SUBJECT: ISSUANCE OF AMENDMENT FOR INDIAN POINT NUCLEAR GENERATING UNIT NO. 3
(TAC NO. M97482)

The Commission has issued the enclosed Amendment No. 175 to Facility Operating License No. DPR-64 for the Indian Point Nuclear Generating Unit No. 3 (IP3). The amendment consists of changes to the Technical Specifications (TSs) in response to your application transmitted by letter dated December 23, 1996, as supplemented February 26, 1997, May 12, 1997, June 16, 1997, July 2, 1997, and July 11, 1997. The amendment changes the TSs to allow for the use of VANTAGE+ fuel for Indian Point Unit 3 fuel cycle 10.

AMENDMENT TO FACILITY OPERATING LICENSE

ATTACHMENT TO LICENSE AMENDMENT NO.175

FIGURE 2.1-1

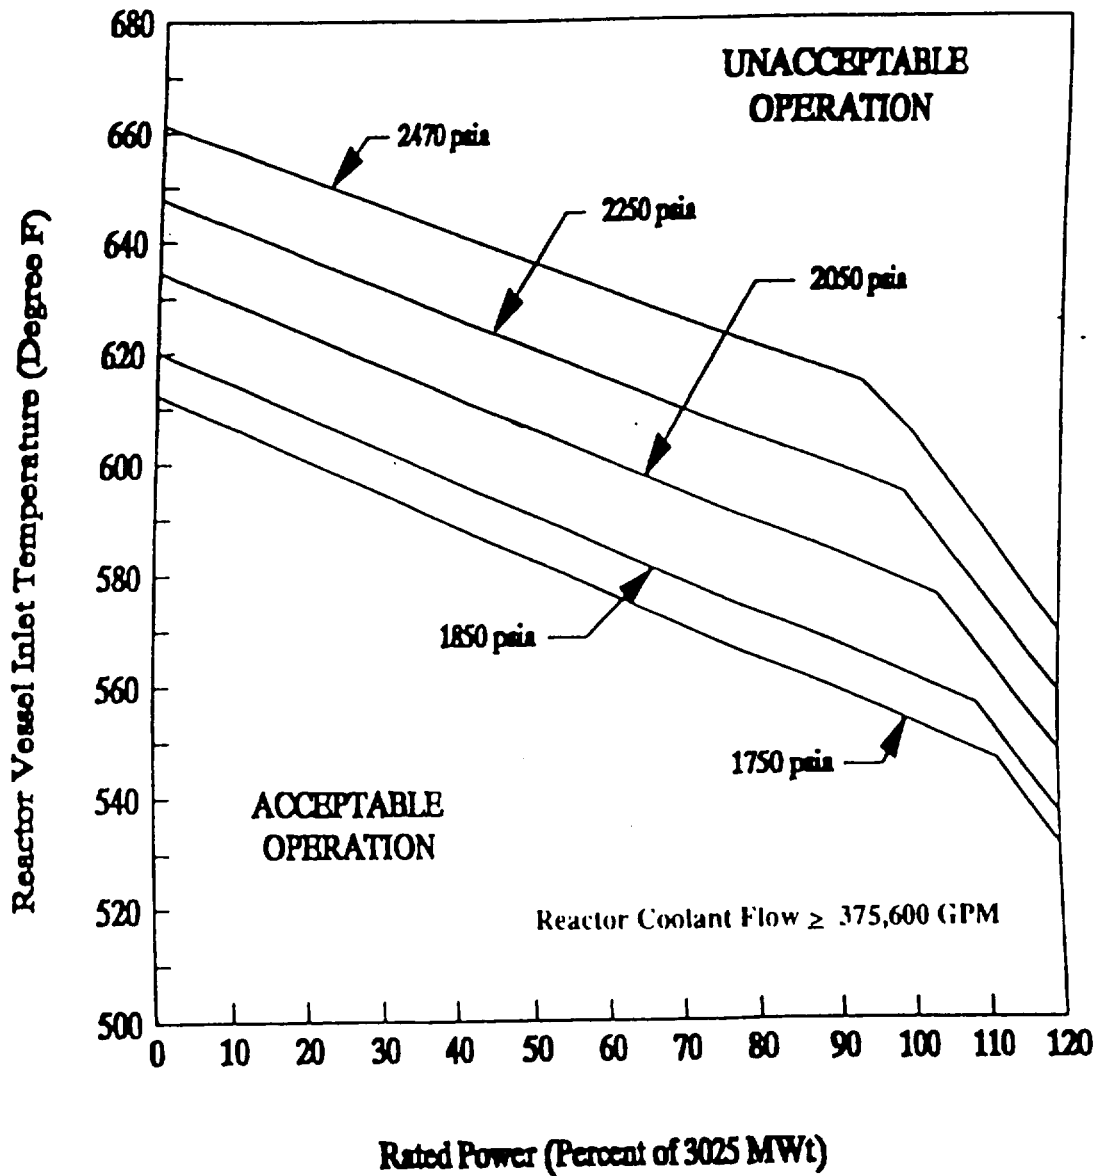
The curves of Figure 2.1-1 show the loci of points of thermal power, Reactor Coolant System pressure and vessel inlet temperature for which the calculated DNBR is no less than the Safety Limit DNBR value or the average enthalpy at the vessel exit is less than the enthalpy of saturated liquid.

Figure 2.1-1 includes an allowance for an increase in the enthalpy rise hot channel factor at reduced power based on the expression:
